DEPARTMENT OF BIODIVERSITY, CONSERVATION AND ATTRACTIONS REPORT

PROPOSAL	Proposed café/restaurant and kiosk at Millers Pool
LOCATION	5 Mill Point Road (Lot 502 on Deposited Plan 424378), South Perth
COST	\$3,000,000
APPLICANT	Giorgi on behalf of Christian Tinelli
LANDOWNER	Department of Planning, Lands and Heritage (leased to the City of South Perth)
LOCAL GOVERNMENT	City of South Perth
MRS CLASSIFICATION	Regional Open Space
DECISION TYPE	Part 5, <i>Swan and Canning Rivers Management Act 2006</i> , Ministerial Determination
ATTACHMENTS	1. Application and supporting documents (149 pages) 2. External referral responses a) City of South Perth (18 pages) b) Department of Planning, Lands and Heritage – Property Services (2 pages) c) Department of Planning, Lands and Heritage – Land Use Management (2 pages) d) Department of Planning, Lands and Heritage – Heritage Council (3 pages) e) Department of Transport and Major Infrastructure – Maritime (3 pages) f) Department of Water and Environmental Regulation – Swan Avon Region (4 pages) g) Department of Water and Environmental Regulation – Environmental Noise (4 pages) h) Water Corporation (5 pages) 3. Summary of public submissions (5 pages)

3 **SOUTH ELEVATION**
1:100

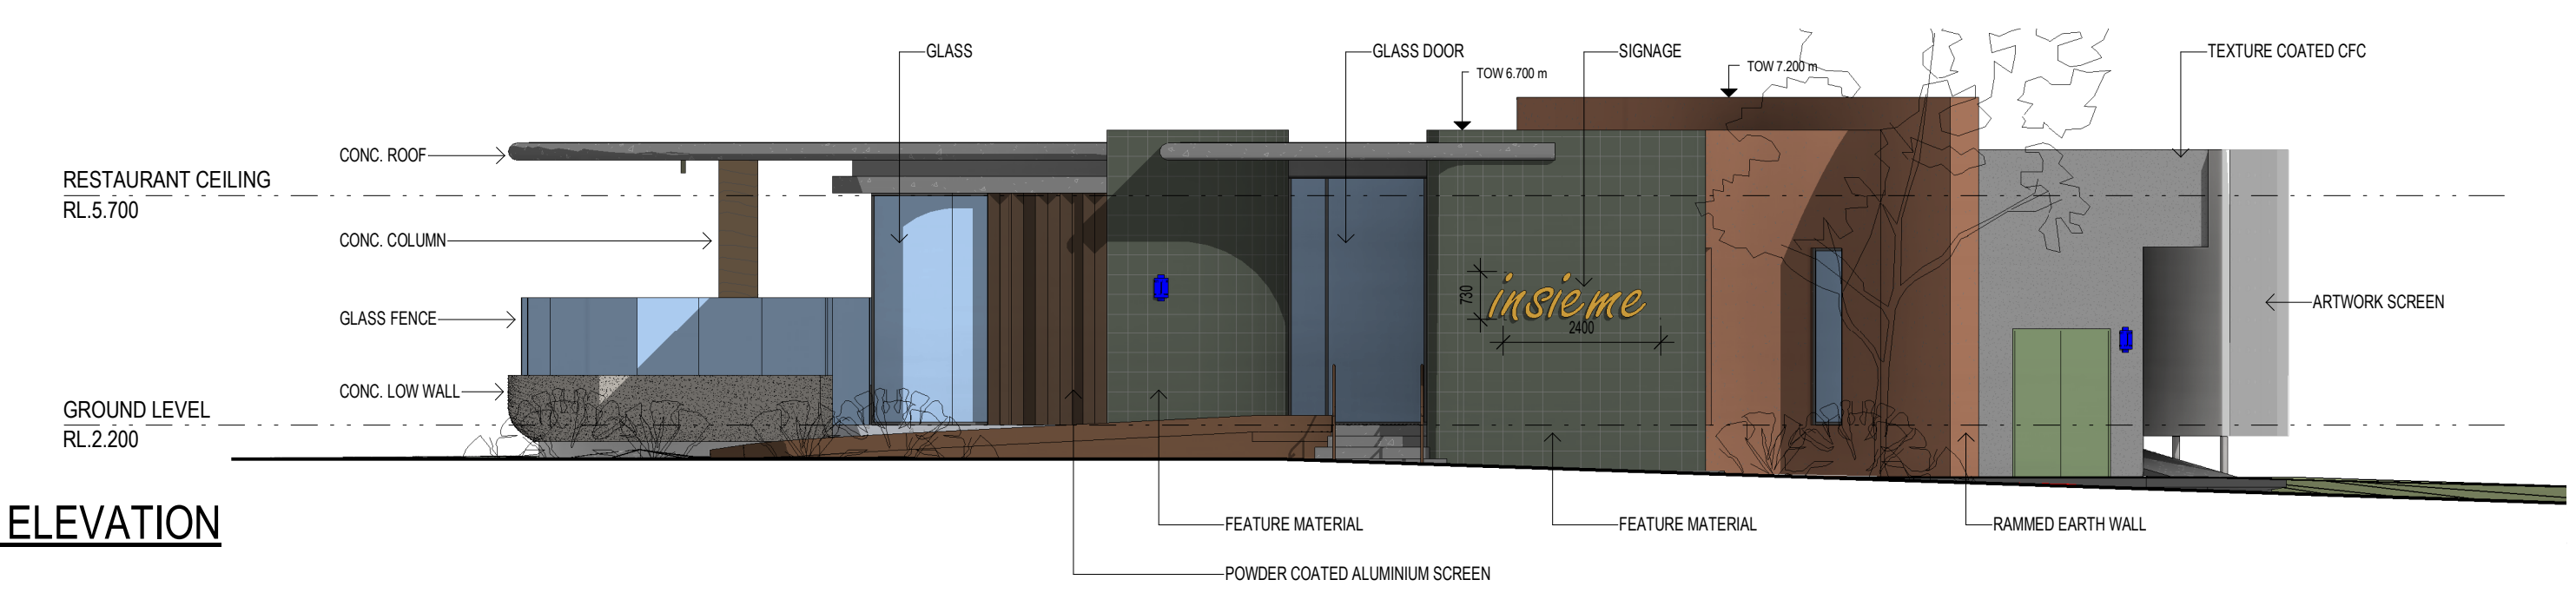
- The design of the proposed south elevation is to be amended to improve views of the building from the State heritage listed Old Mill site, and from Mill Point Close, and to better address Millers Pool and the parkland setting of the site.

2.13 The proposal was subsequently amended to provide screening to plant (e.g. air conditioning and cooking exhaust) to ensure that views from the Old Mill site, and from Mill Point Close are not adversely affected by the proposal.
